**Other RCRA
Correspondence
2021**

**NEW MEXICO
ENVIRONMENT DEPARTMENT
Hazardous Waste Bureau**

**RE: APPROVAL WITH MODIFICATIONS
RESPONSE TO DISAPPROVAL INVESTIGATION WORK PLAN SOLID WASTE
MANAGEMENT UNIT (SWMU) NO. 1 AERATION BASIN AND SWMU NO. 14 OLD API
SEPARATOR
WESTERN REFINING SOUTHWEST INC., GALLUP REFINERY
EPA ID # NMD000333211
HWB-WRG-14-005**

FIGURE 2
INVESTIGATION AREA

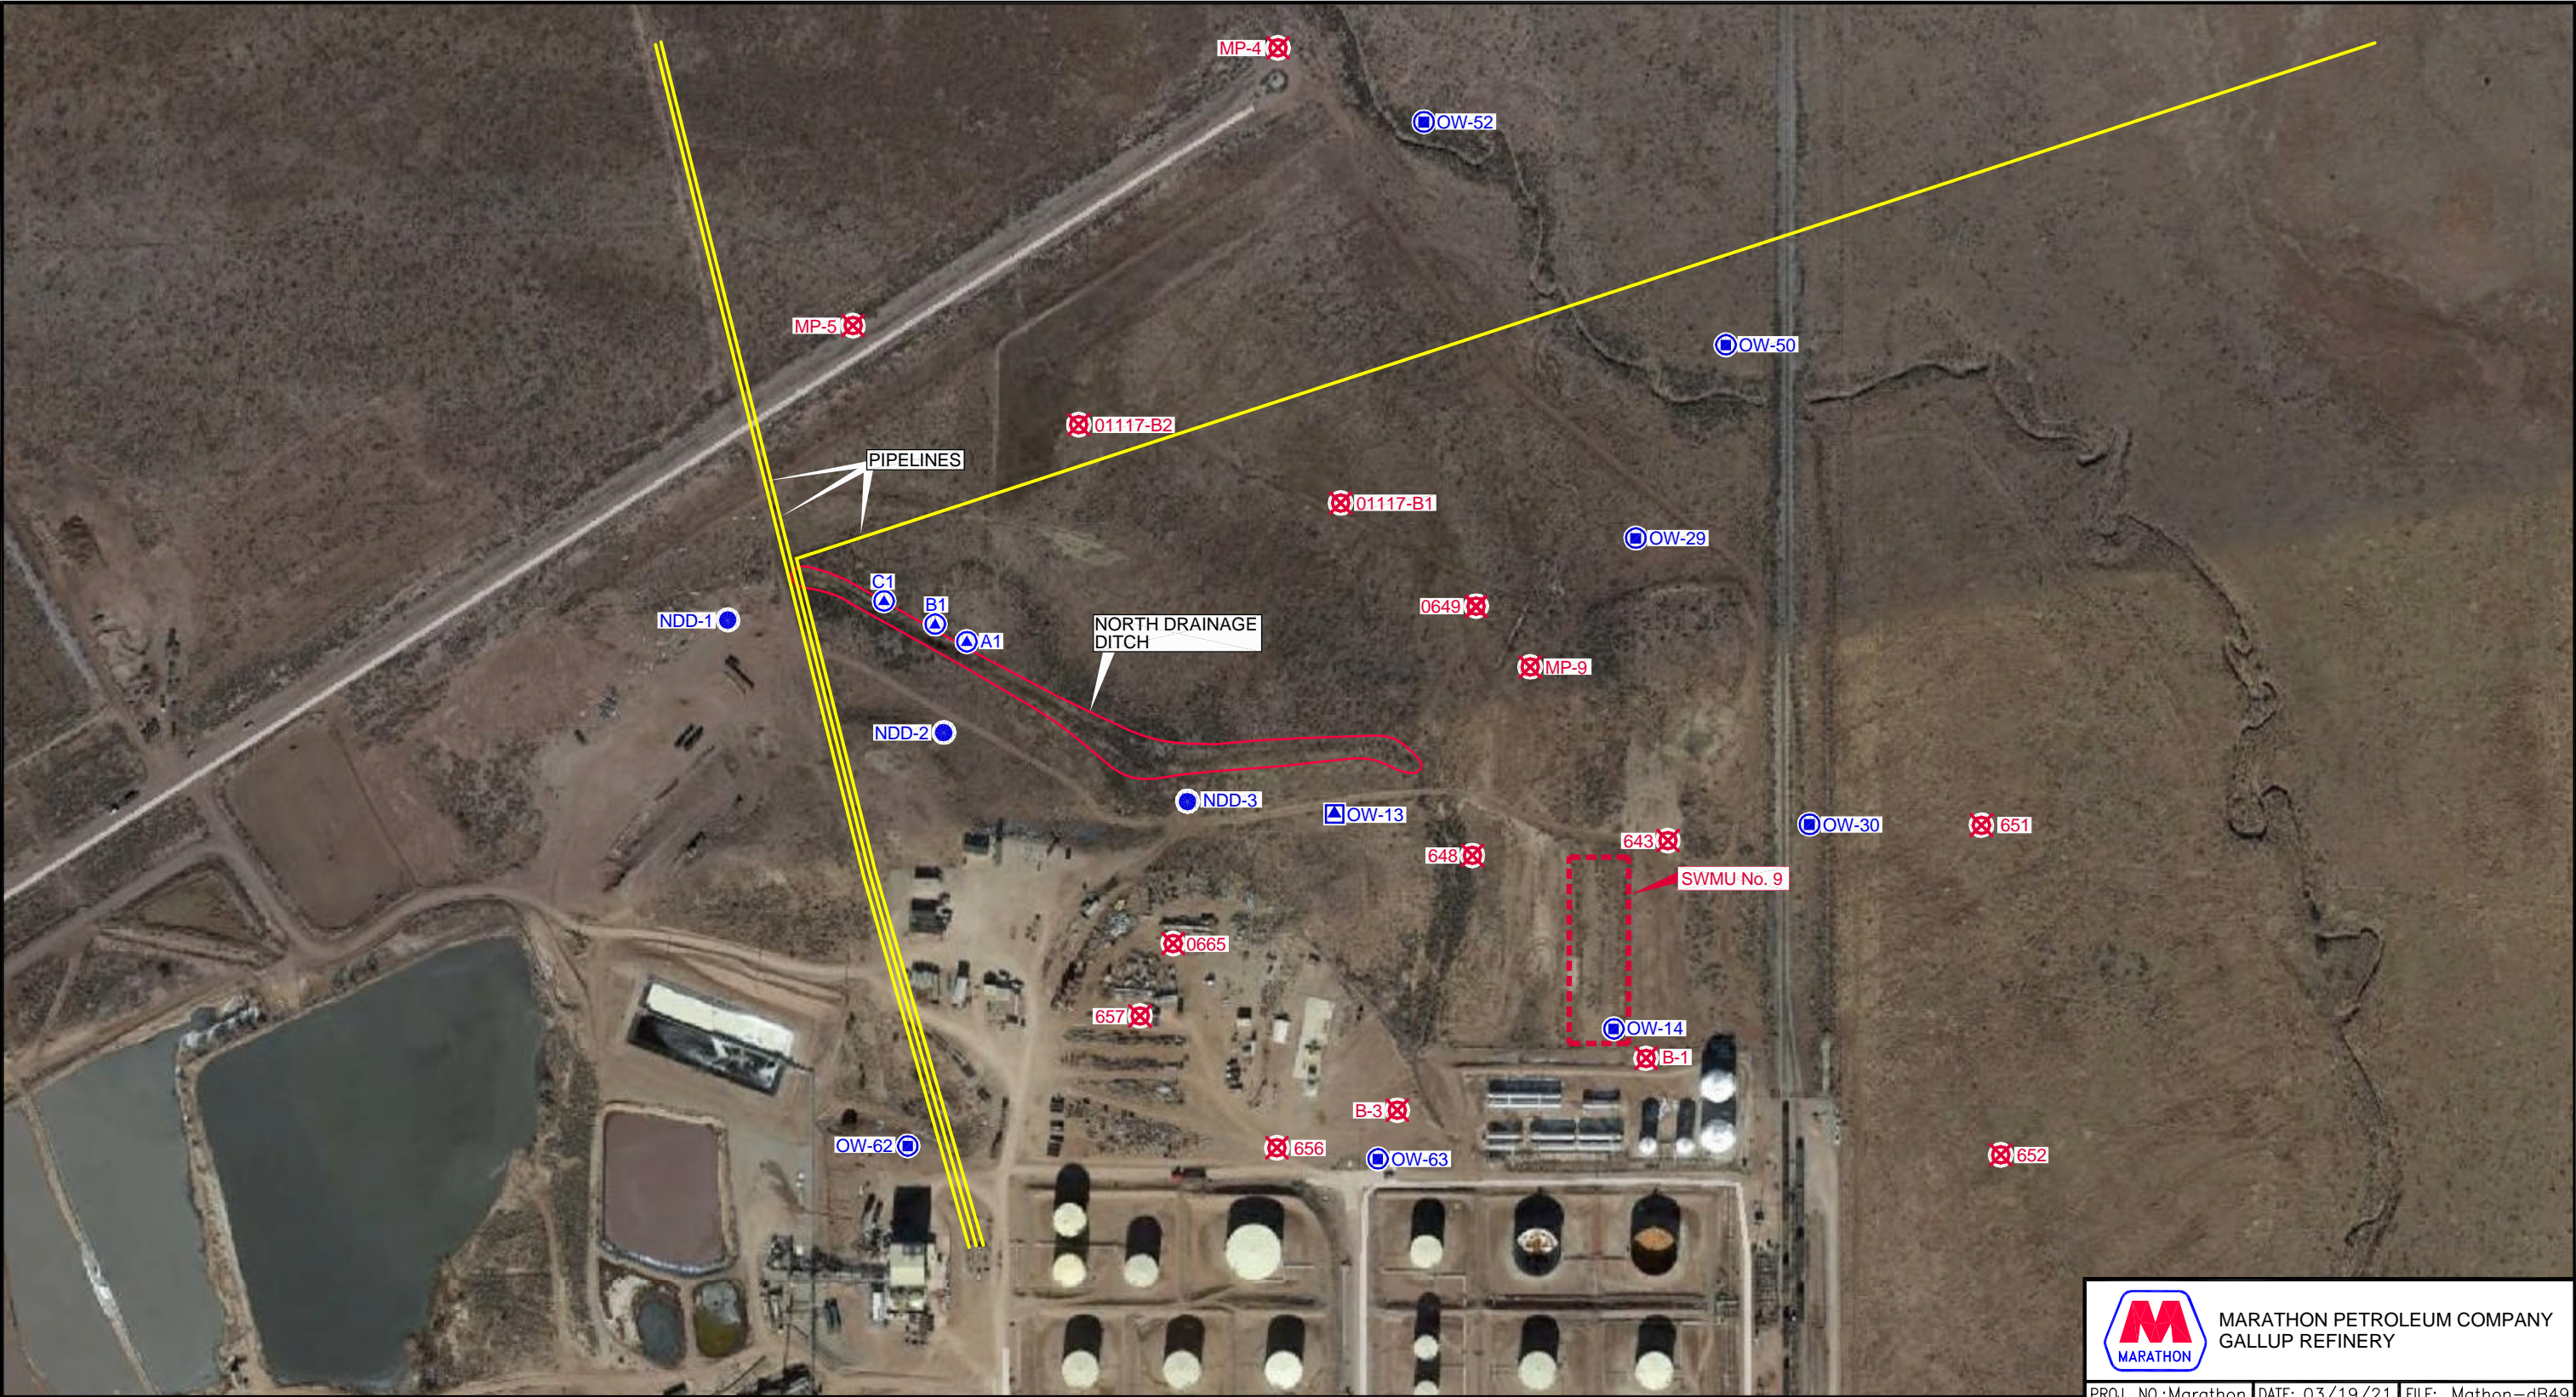
The response to NMED's Disapproval Comment 2 states, “[t]he missing historic borings [01117-B1, 01117-B2, 648, 643, 649, 651, 652, 665, 656, 657, MP-4, MP-5, MP-9, B-1, and B-3] are included in Appendix B...” The boring logs are appropriately included in Appendix B; however, the Work Plan does not include a figure that identifies the location of the borings. Provide a figure that identifies the location of the historic borings.

Figure 2 in the Work Plan has been revised to include the location of the historic borings. Attached to this correspondence is a copy of Figure 2.
